Bexley Architectural Review Board
Staff Report
Special Meeting for 424 South Columbia
November 5, 2020 (via Zoom)

Application No.: ARB-20-63
Applicant: Sullivan Builders Inc.
Owner: Summit Shah
Address: 424 S Columbia
ARB Request: To approve modifications to the original design and to approve solar panels.
Staff Comments: This project, originally approved in February, 2018, has been built *not* according to approved plans. The applicant is before the Board to go over modifications to the original designs and proposed resolutions. Additionally, the applicant is seeking approval for the addition of solar panels on the roof as submitted. This case is for the issuance of a new Certificate of Appropriateness.

West (Front) Elevation:

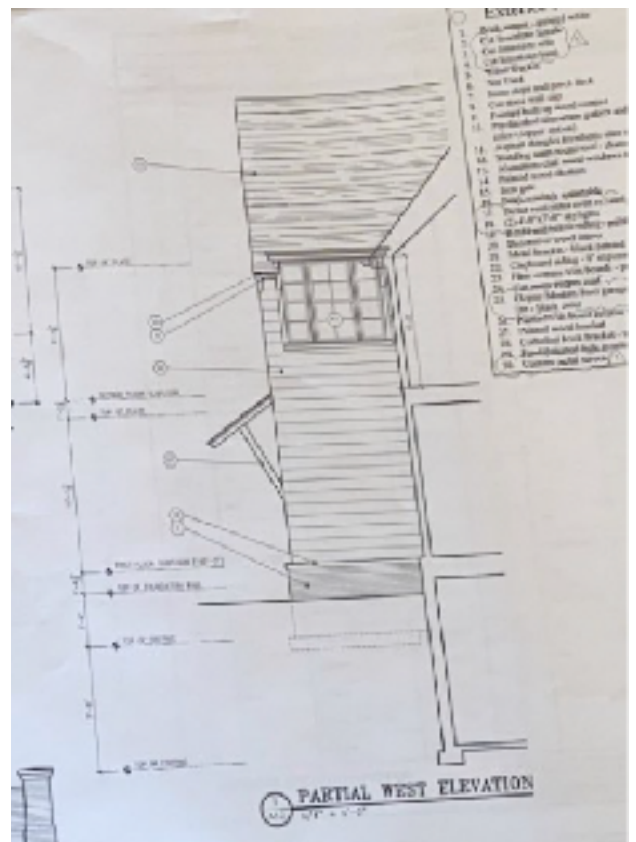
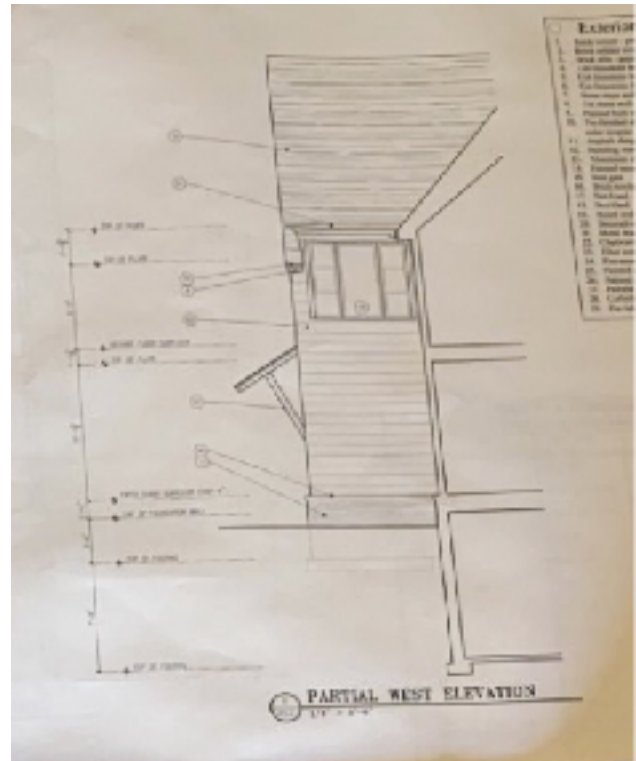
- Ridge height changed from 36' 6" to 39' 3" (max allowable is 40')
- Window grid pattern changed
- Brick lintels used instead of limestone - will be changed to limestone in accordance with original design.
- Grade changes

South Elevation:

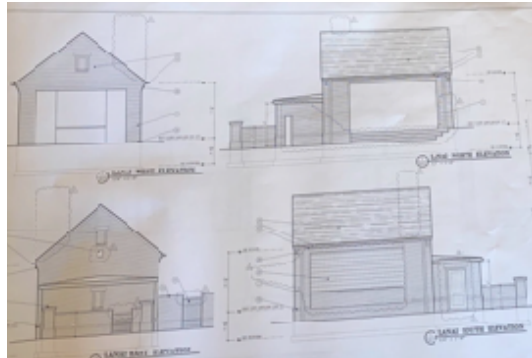
- Ridge height changed
- Window grid patterns, sizes and placement changed
- Brick lintels used instead of limestone - will be changed to limestone in accordance with original design.
- Skylights added
- Relocation of stone wall behind Lanai

Plans:

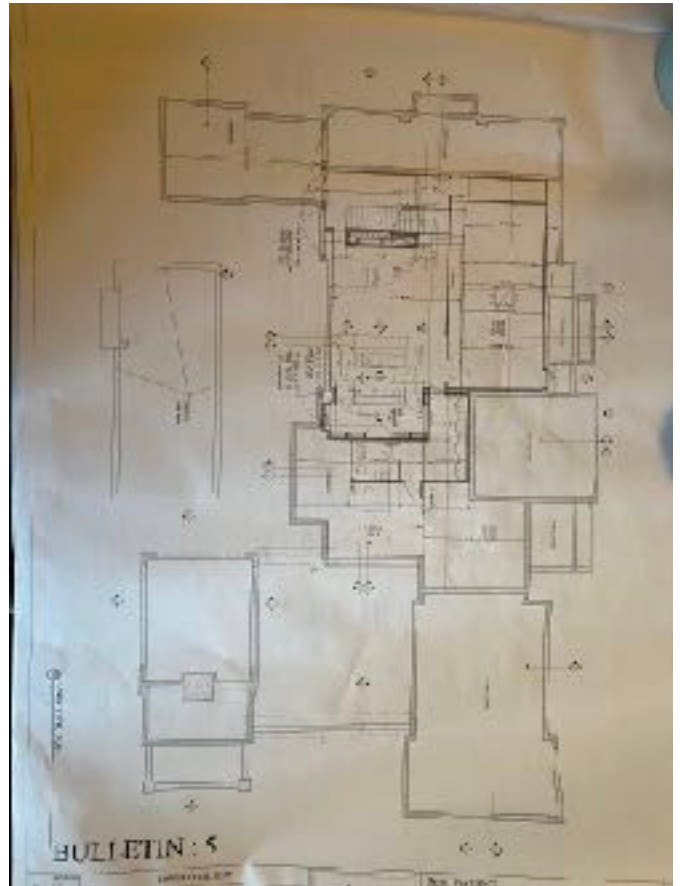
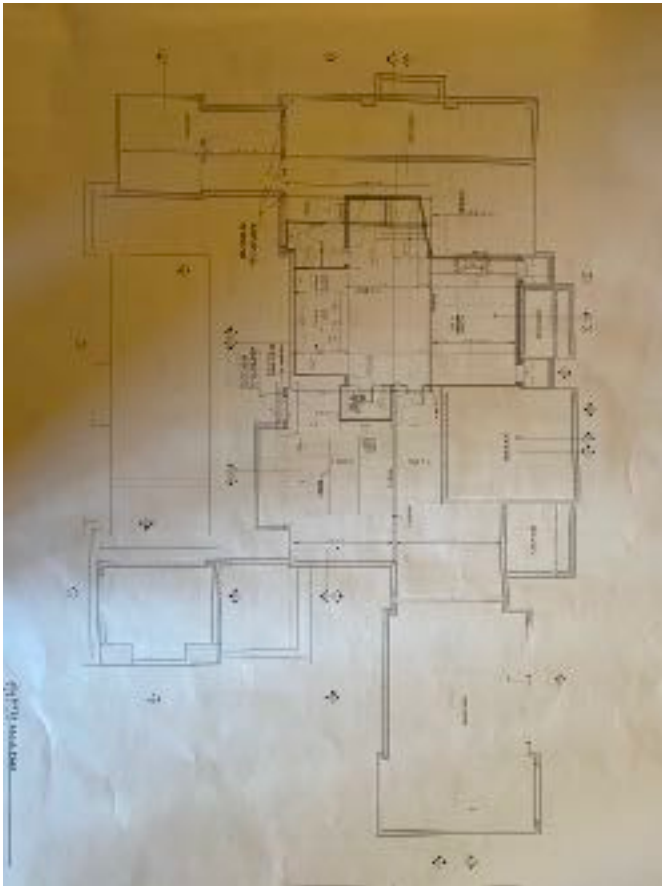
- Ridge direction of poolhouse changed and footprint increased in size due to storage and pool equipment area.
- Gate and wall changes
- Increase in pool size
